# Technical Bulletin

<b>DATE:</b> 6/7/96	<b>PRODUCT:</b> All CD Jukeboxes with S-6 Computers and CDM12 Players (Production Dates: 4/95 thru 3/96)	<b>NO:</b> 5021
---------------------	--	-----------------

**SYMPTOM:** Compact Disc will intermittently be put down on to the player and will cancel without playing or spin briefly and then cancel.

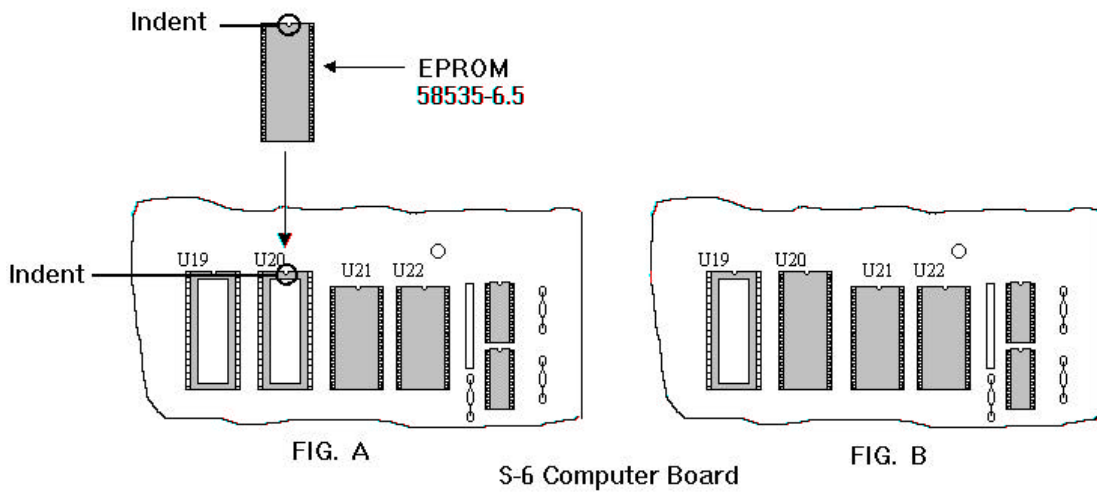
**INSTALLATION:** When installing a new Eprom, make sure the power to the jukebox is turned off. Remove the computer cover. Gently remove the old Eprom and replace with the new Eprom #58535-6.5. The RAM memory IC in space U22 must be removed and re-inserted to ensure them that the memory is cleared out.

**Note:** Make sure that you match the indents together identical to picture in Fig. B.

**ACTION:** If you should experience the above symptom, contact our office to order **58535-6.5 Eprom** to correct the above symptom. The new Eprom will upon receiving a playing error cause the mechanism to reject the disc, scan around to the disc again and then retry it.

**IMPORTANT:** Dip switch #9 must be set on (FIFO) for this to work properly.
